Amendments to the Drawings:

## **REMARKS**

"Annotated Marked-up Drawings"

Fig. 4

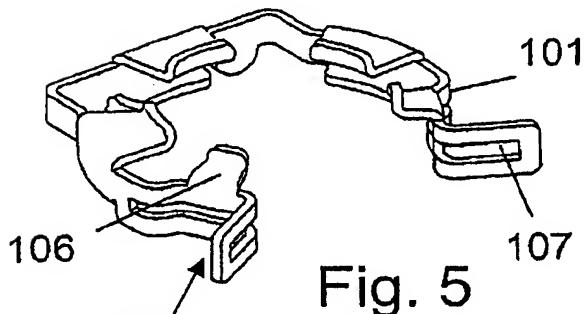
Figure 4 has been amended to more clearly refer to a preferred embodiment by identifying edge (12).

With respect to claim 4, Applicants have amended Figure 4 to include reference numeral 12 which shows the claimed sharp edge. In light of the exemplary depiction of a “sharp edge in the region of bearing contacts” in Figure 4, Applicants submit that claim 4 is clear and definite.

Fig. 5

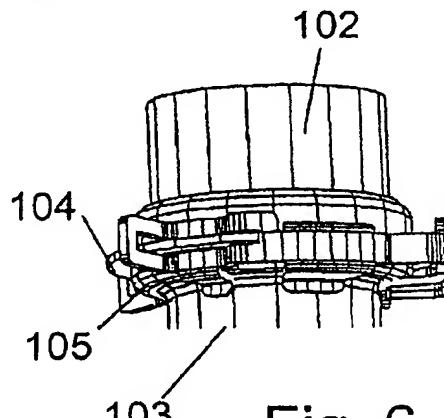
Further, figures 5-7 have been amended to include the label “PRIOR ART”.
